Modification of Development Consent

For the following: Eastern Creek Waste Project

Modification 8

Modification Application: 06_0139-Mod-8

APPENDIX 6
Materials Processing Centre 2 and Future Stormwater Plan

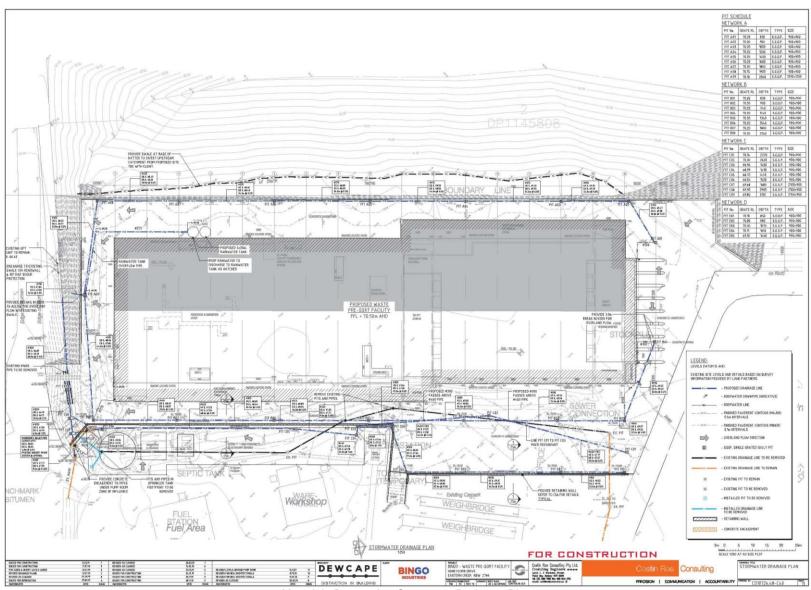
- 10. Replace Appendix 1 with new Appendix 1.
- 11. Replace Appendix 6 with new Appendix 6.

Proposed Future Stormwater Management Plan (Dwg SKC007P6.26)

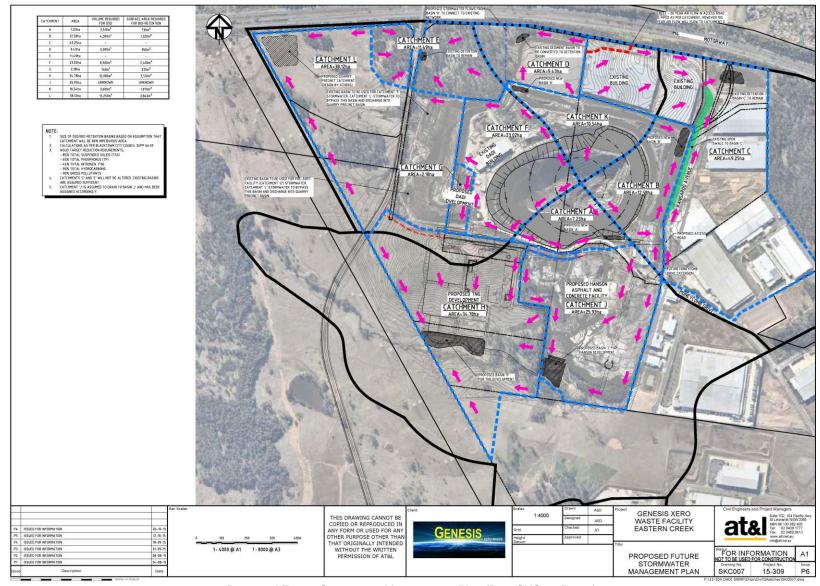
- 7. Delete Conditions 25a and replace with the following:
 - 25a. Within 3 months of the approval of Mod 8, the Applicant must prepare an Interim Stormwater Management Plan for the Materials Processing Centre 2, car park and weighbridges, to the satisfaction of the Planning Secretary. The plan must:

- a) be prepared in consultation with Council and the EPA;
 - b) include details and specifications for the detention basins in Catchment G (as shown in Proposed Future Stormwater Management Plan, Drawing No. SKC077, Issue P6, dated 26 October 2015; and letter from Genesis Xero Waste to Blacktown City Council, dated 4 November 2015); and
